Technical Service Bulletin

TBJ008D

Date: July 24, 2008

Product: ATP32U01 & ATA32U01 (ATP32U02 are not effected) thermostats configured for multi-stage operation.

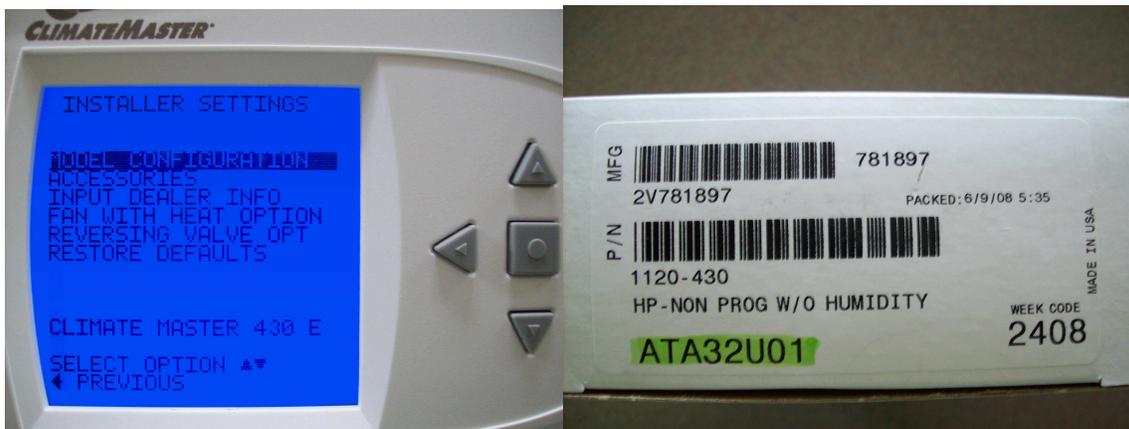
Issue: A quantity of thermostats have a manufacturing defect which prohibits a "Y2" call controlling second stage heating, cooling or two-speed fan operation. Only thermostats configured for multi-stage operation are effected, units configured for single stage operation will function properly.

Effected Range: Thermostats that were produced in May and June of 2008. Uninstalled thermostats can be checked by the date code and/or part number. The thermostat's box label (shown lower right) lists the part number and date code (first 2 digits indicate week, last 2 digits indicate year). Return any thermostat with date code of **1808** through **2808** without the part number highlighted in green. Corrected thermostats have either a date code of **2908** or later or any date code in the affected range with the part number highlighted in green. Example would be of lower right picture; even though date code is between **1808** and **2808**, the part number is highlighted in green indicating this thermostat has been corrected. Installed thermostats should be checked by the revision codes (shown in lower left picture). Compare revision codes to the chart listed below.

THERMOSTAT PART NUMBER	EFFECTED REVISION CODE
ATA32U01	430E
ATP32U01	431E

Solution: First, determine if you have thermostats in your stock that need to be replaced. Next, communicate with all your customers that have purchased the subject thermostats and assist them with their exchange and/or replacement of thermostats. See contractor technical bulletin and thermostat return form attached.

Effected thermostats must be replaced and returned to ClimateMaster. Replacement thermostats must be ordered through the Business Center, credit will be issued upon receipt of returned
